CHINOOK INTERMUNICIPAL SUBDIVISION & DEVELOPMENT APPEAL BOARD

Hearing No. DA2026-11

PROPOSAL: 3 Multi-unit Buildings – 20 Unit Total (Dwelling Group)

I, along with the residents of the surrounding blocks of the proposed development site, would like to formally oppose and appeal the decision made by the Town of Raymond Municipal Planning Commission.

SHEET NAME
SITE PLAN

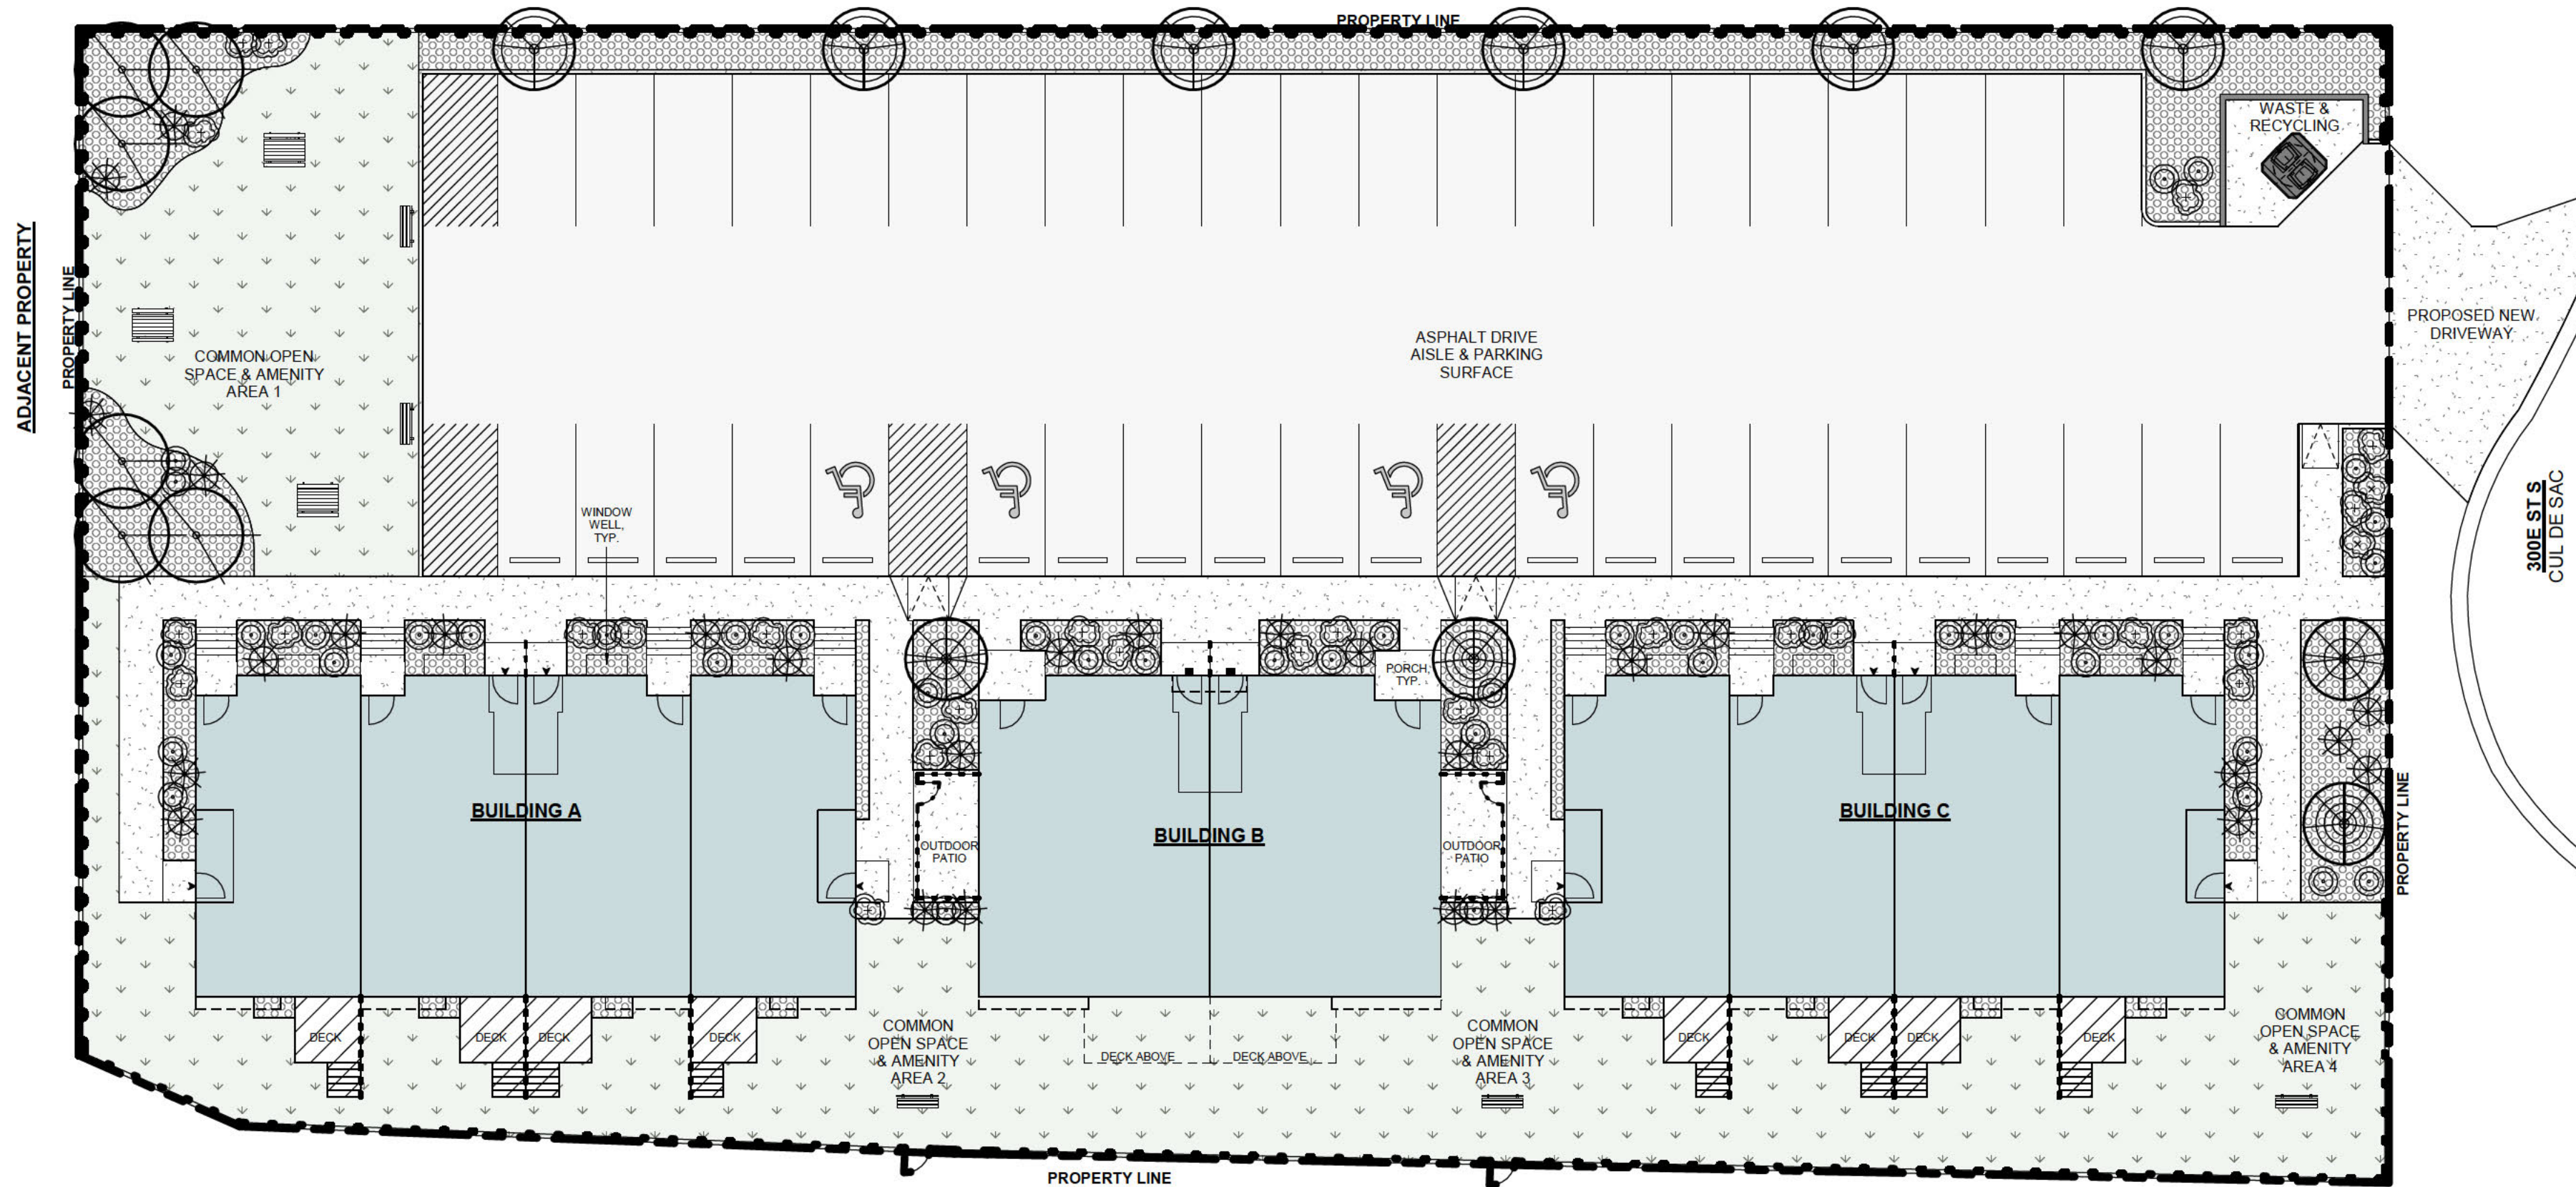
Based on the submitted site plan, the proposed parking area appears to significantly exceed the intended limits for impervious surface coverage. Using the dimensions provided in the parking layout, the estimated hard-surfaced parking area alone covers approximately 45.8% of the total site area.

Concerns regarding this level of impervious surface coverage were raised with the Municipal Planning Commission. However, no clear response was provided, and the issue does not appear to have been substantively addressed in the decision rationale. The reliance on a "traditional" interpretation by ORRSC does not resolve the underlying bylaw requirement or the question of applicability.
